## Ashton Village Center Sector Plan—Work Session Number 2

To receive guidance from the Planning Board on the transportation and circulation recommendations, community design and design guidelines, and implementation recommendations in the Ashton Village Center Sector Plan.

*Figure 3. 2019 aerial view of the MD 108/650 intersection. The turning radius in the northeast corner is very tight, especially for longer vehicles and those with trailers, which led SHA to move the stop bar for southbound MD 650 well back from the intersection.*

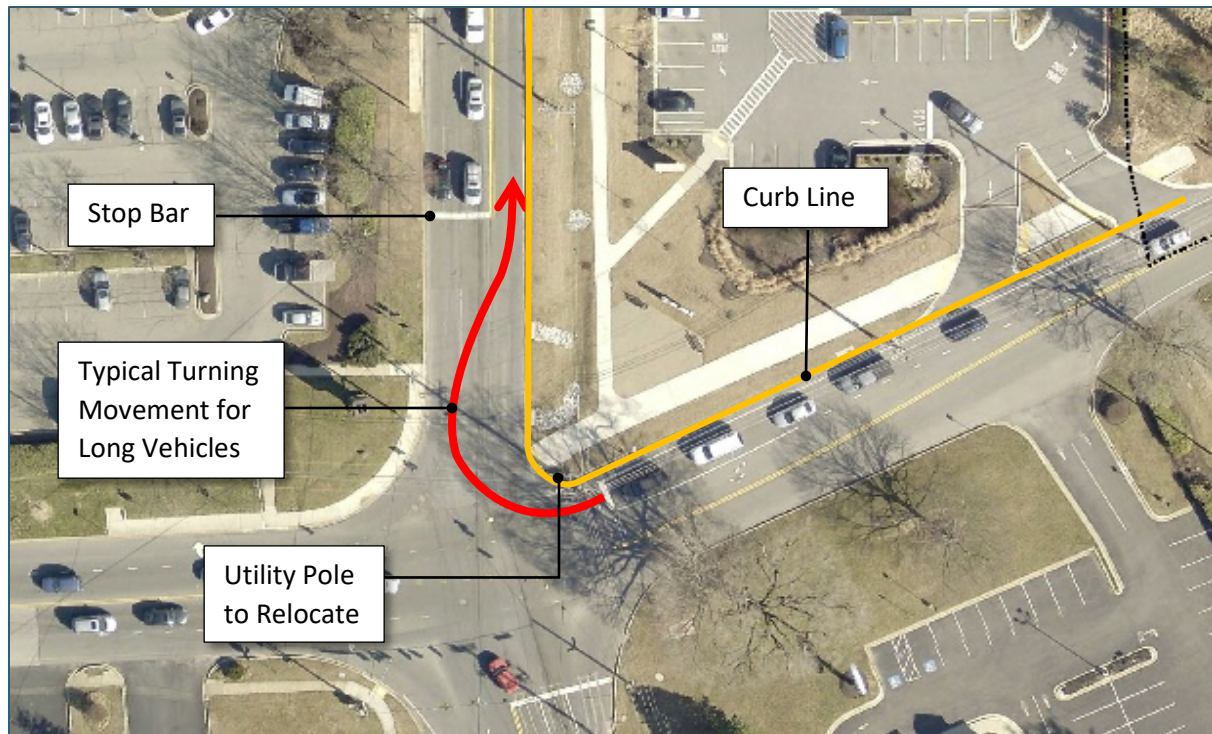
*Comments:* Several of the comments support the Plan’s MD 108/650 intersection improvements, including moving the pole at the corner of New Hampshire Avenue and Route 108 without expanding the overall size of the intersection.

*Plan Recommendation 4.1.4 #2:* Relocate the utility pole at the corner and modify the curve to enable easier vehicle turning without negatively impacting pedestrian safety.

*Staff Response:* Retain the Plan’s recommendation.

*Figure 4. Architectural embellishments provide visual interest to building massing.*

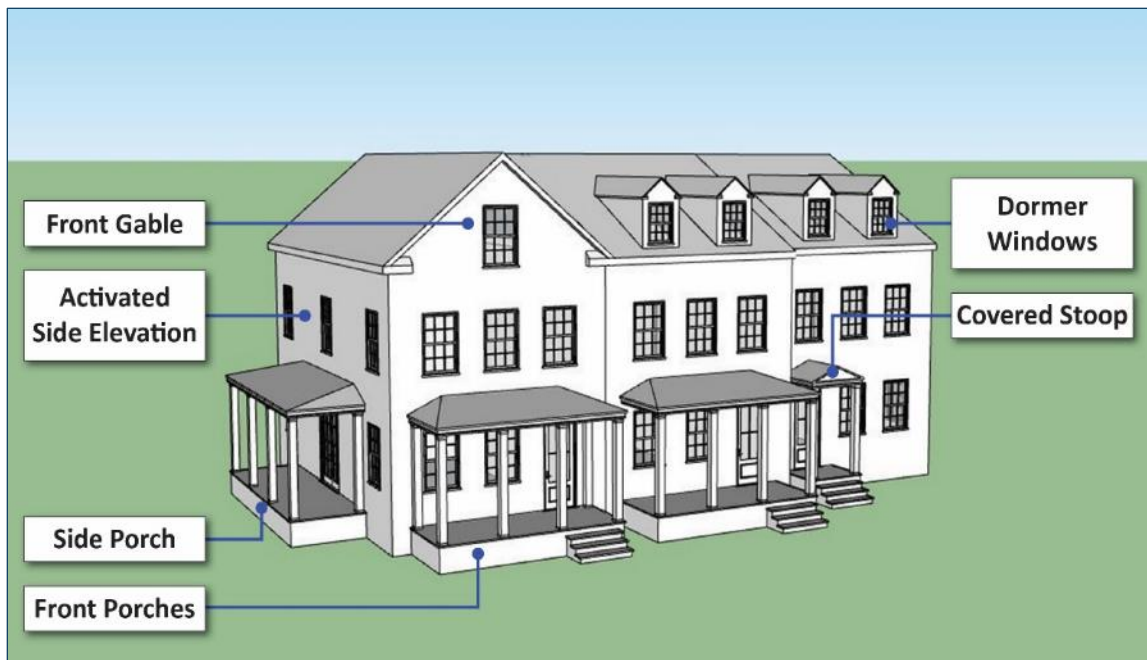
*Plan Recommendation 3.3.2 #11:* Incorporate architectural elements in the façades, such as front and side-turned gables, front and side porches, covered stoops, recess entries, bay windows, dormer windows and cupolas.

*Staff Response:* Retain the Plan's recommendation. Figure 4 below shows several of the architectural embellishments recommended in the Plan designed to retain rural character in Ashton. The design guidelines as written attempt to require the architectural elements being requested. Enforcement would be through site plan review and possible comments from an implementation advisory committee.
